Technical Service Bulletin

DATE September 1, 1967NUMBER 67DT-15 MODEL AXLEGROUP ELECTRICAL SUBJECT ALTERNATOR RATED OUTPUTSUMMARY ALTERNATOR RATED OUTPUT IS RELATED TO PART NUMBER, ENGINE AND TRUCK MODEL.

DATE August 25, 1967
NUMBER 67DT-16 **MODEL** LN, LNT1000
GROUP ELECTRICAL **SUBJECT** IMPROVED AIR-OPERATED WINDSHIELD WIPER MTR. KIT
SUMMARY IMPROVED AIR WIPER MOTOR KIT REPLACES WIPER MOTOR IN CURRENT USE ON HEAVY DUTY TILT CAB TRUCKS.

DATE October 6, 1967
NUMBER 67DT-25 MODEL P200 Post Office Dept. Trucks (S-6)
GROUP Electrical SUBJECT Service Procedures for Modified Charging System
SUMMARY Modifications and Service Procedures for P200 Charging Systems are Detailed.

FIG. 1 SIMPLIFIED SCHEMATIC
USPO 640000 SERIES
P200 CHARGING SYSTEM

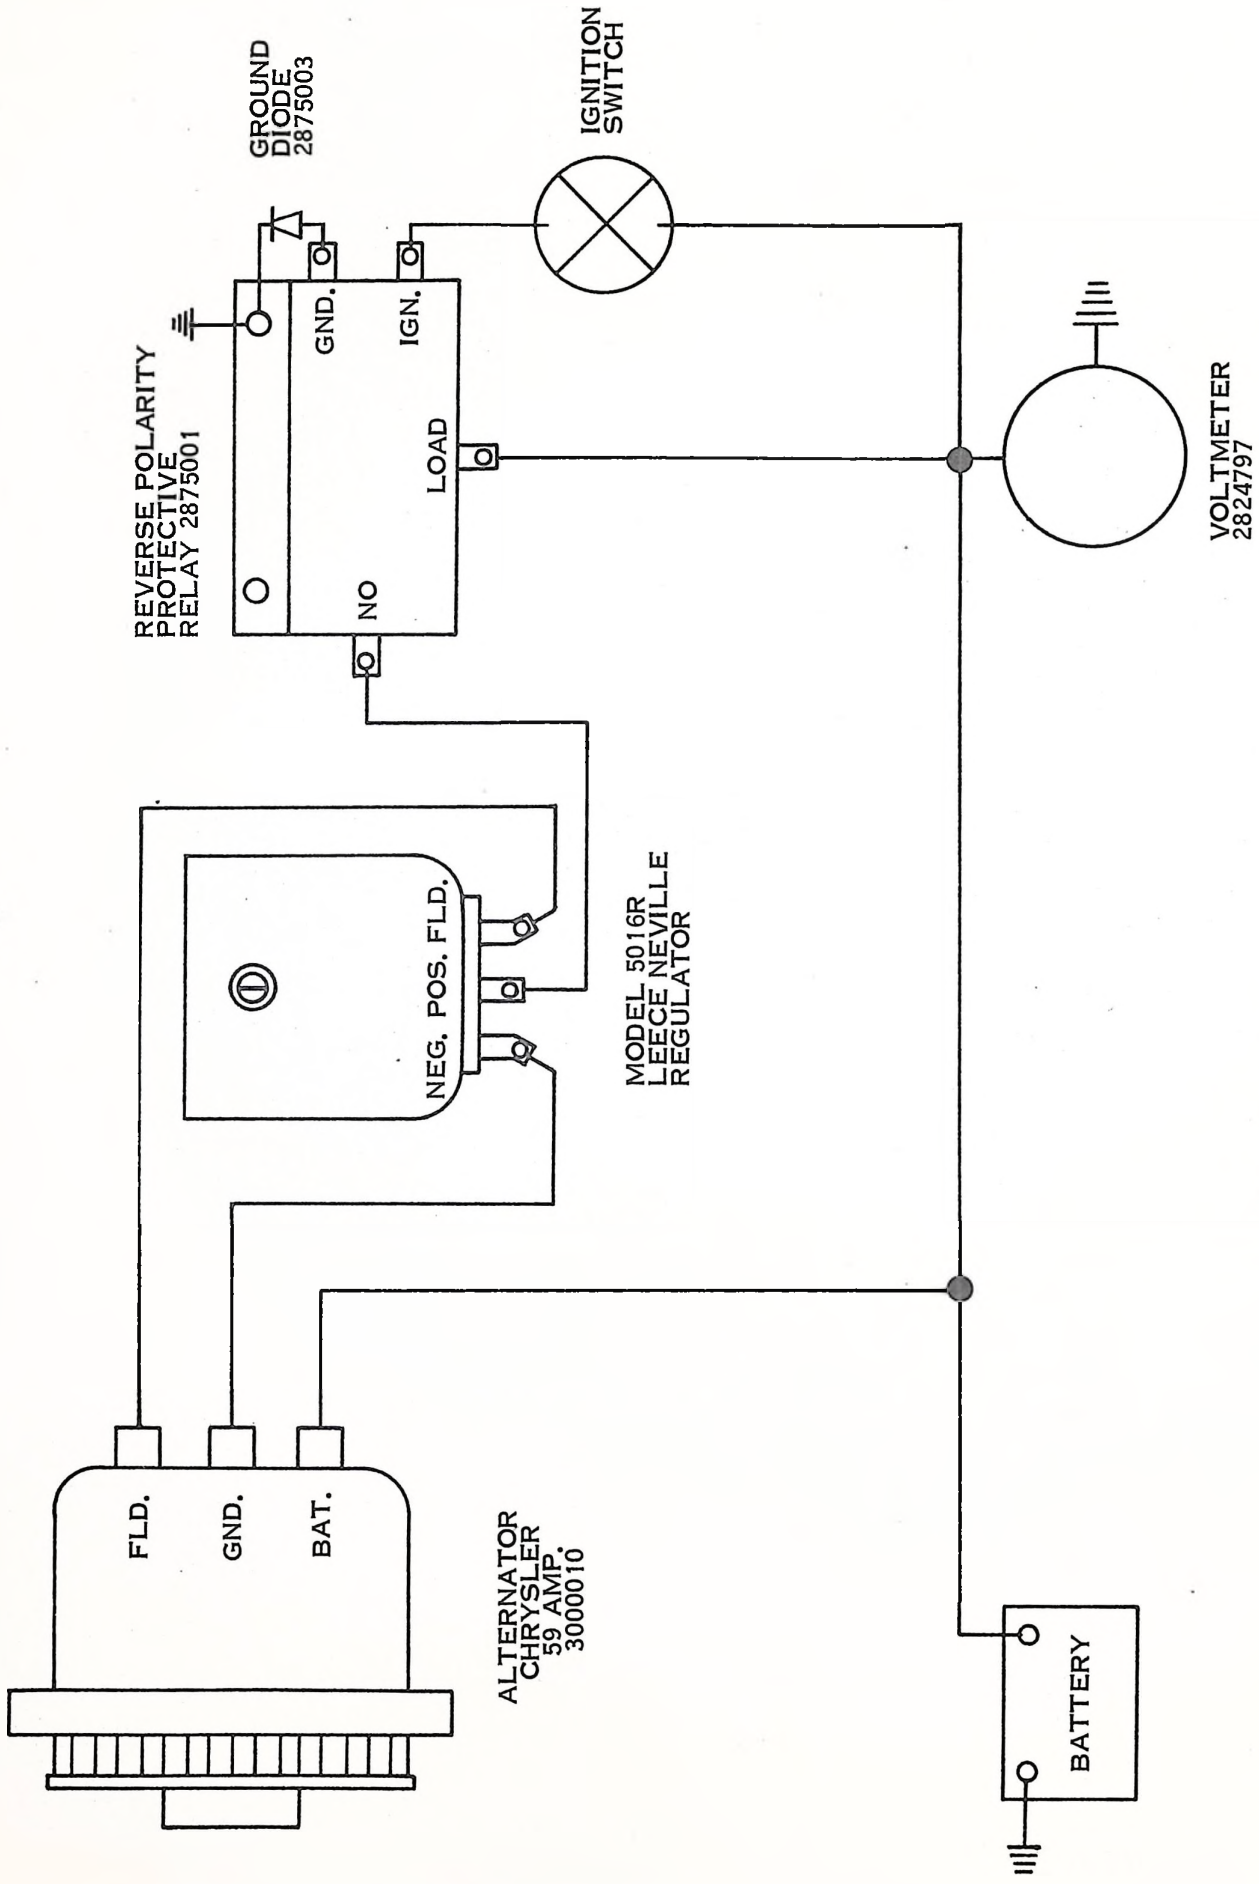
The charging system of Model P200 Post Office Trucks has been modified to incorporate a reverse polarity relay to protect the transistorized regulator from the effects of reverse battery polarity. This modification, shown in schematic form in Figure 1, applies to 6P200 Model trucks, USPO Registration Number Series 640000, produced under contract GS-00S-59968. Service procedures described in Technical Service Bulletin 66DT-13 apply to P200 Post Office Trucks produced previously.

FIGURE I. HEATER SWITCH REWORK

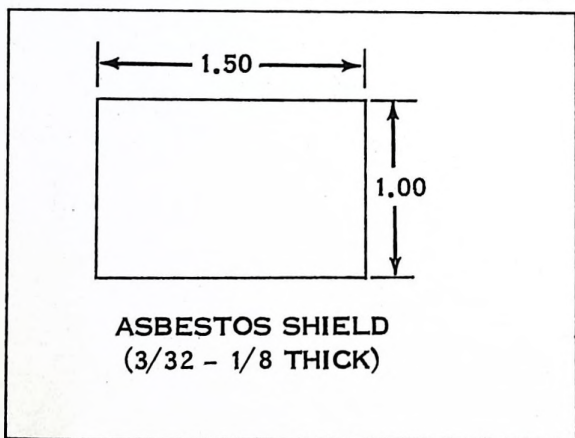
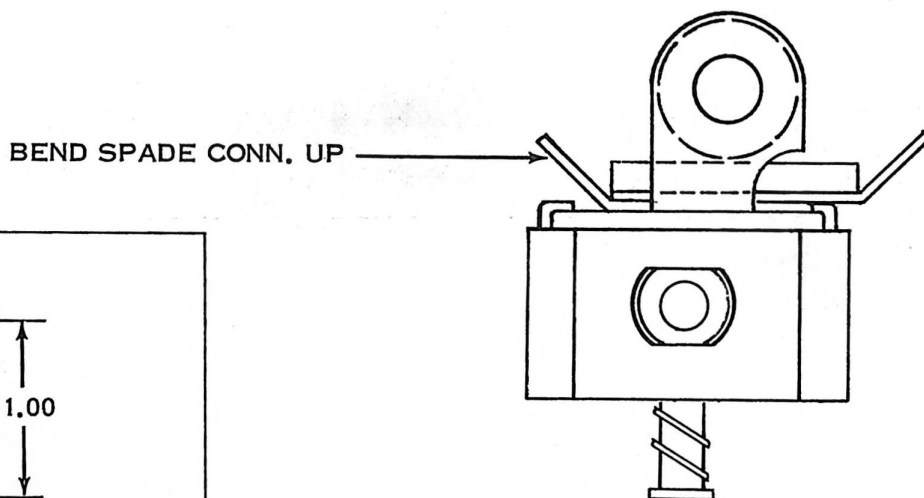
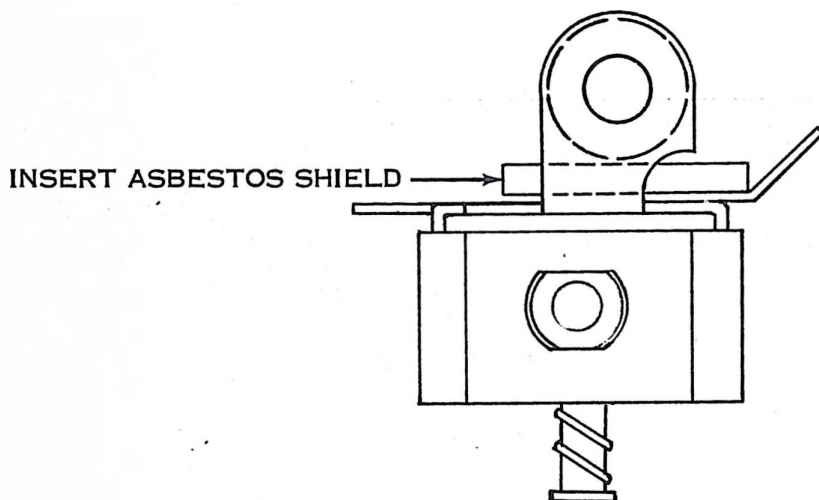
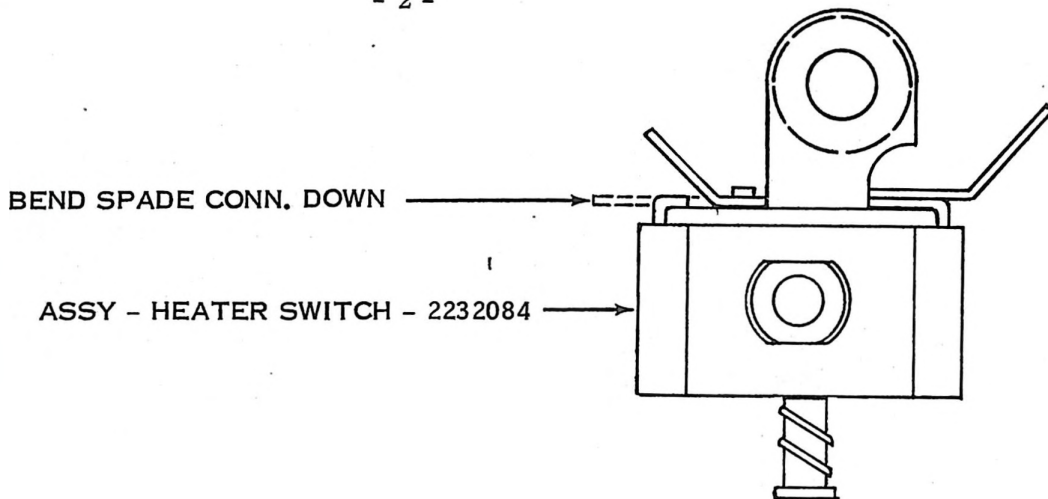
The push-pull truck heater blower switch (P/N 2232084) has proven to be subject to early failure because of extreme heat radiation by the resistor. The closeness of the resistor to the switch assembly proper causes terminal failure because of heat transfer.

Switch rework is simple, fast, and effective. The entire operation is detailed in Figure 1 and involves only the insertion of an asbestos heat shield, 1 1/2" X 1" from 3/32" to 1/8" thick, between the high wattage resistor and the switch body. Refer to Figure 1.

1. Bend spade connector down.
2. Insert asbestos heat shield.
3. Bend spade connector up.
